H. B. ROBINSON STEAM ELECTRIC PLANT, UNIT NO. 2  
DOCKET NO. 50-261 / RENEWED LICENSE NO. DPR-23

**SUPPLEMENT TO REQUEST FOR TECHNICAL SPECIFICATION CHANGE TO REACTOR  
COOLANT SYSTEM PRESSURE AND TEMPERATURE LIMITS**

**RESPONSE TO SUPPLEMENTAL INFORMATION REQUEST REGARDING REQUEST FOR  
TECHNICAL SPECIFICATION CHANGE TO REACTOR COOLANT SYSTEM PRESSURE AND  
TEMPERATURE LIMITS**

Figure 1 CO-59 (n,  $\gamma$ ) Cross-Section

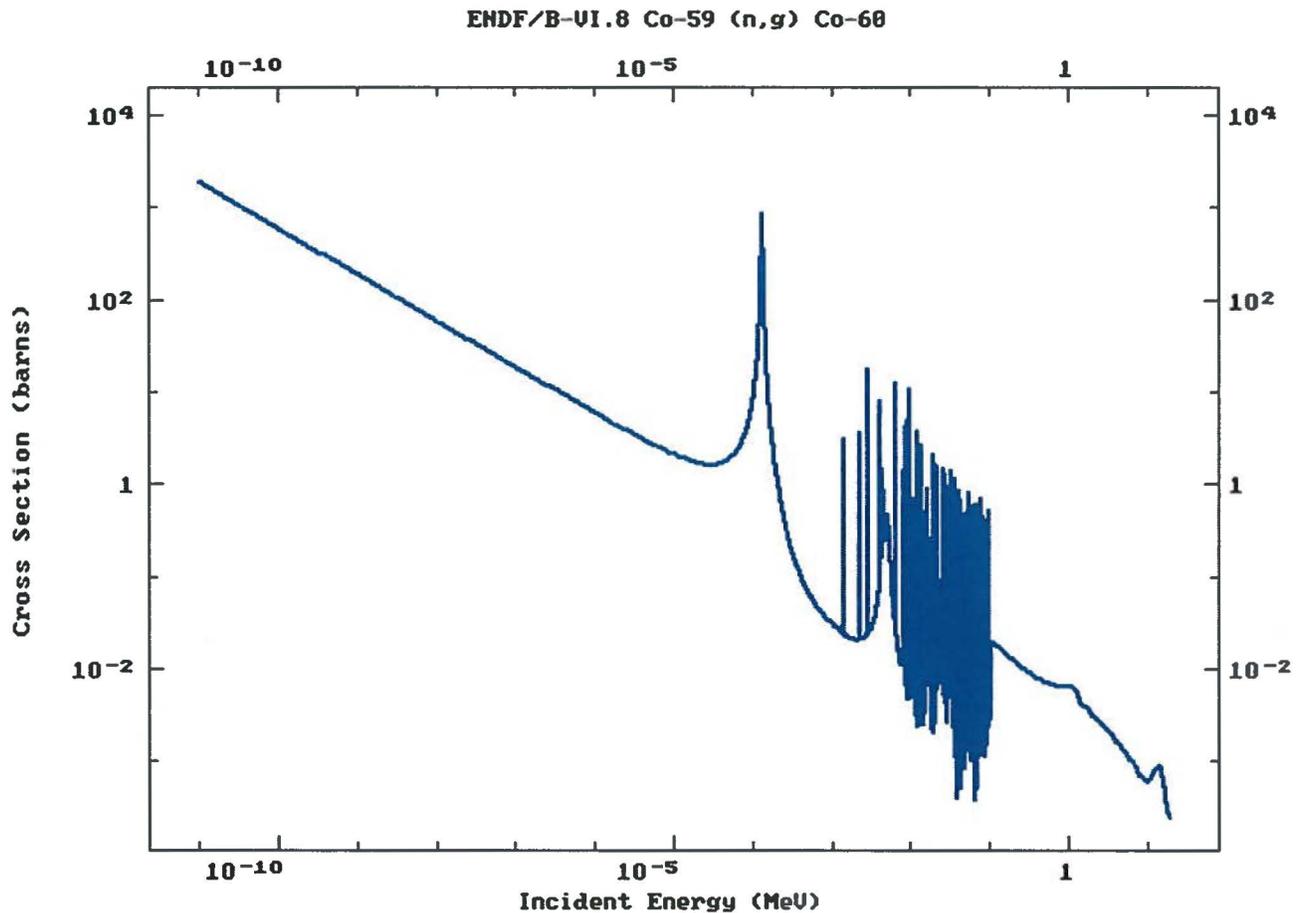
The NRC staff noted that the unadjusted C/M summary table provided in Table 6-11 of WCAP-15805 excludes all cobalt dosimeter data and the report does not explain why. Explain why it is acceptable to remove this data.

A plot of the Co-59 (n,  $\gamma$ ) reaction cross-section from the ENDF/B-VI.8 library, obtained from Reference 4, appears in Figure 1. This reaction is predominately sensitive to neutrons in the thermal energy range. As such, it does not provide a meaningful measurement of neutrons of interest in this application, those neutrons with energies greater than 1.0 MeV. Per ASTM E262 (Reference 5), the cadmium shield selectively removes neutrons with energies below approximately 0.55 eV, but this still results in the cobalt dosimeters being predominately sensitive to neutrons with energies well below the region of interest for this application. As such, cobalt measurements are typically excluded from consideration when comparing measurements to calculations for fast fluence benchmarking.
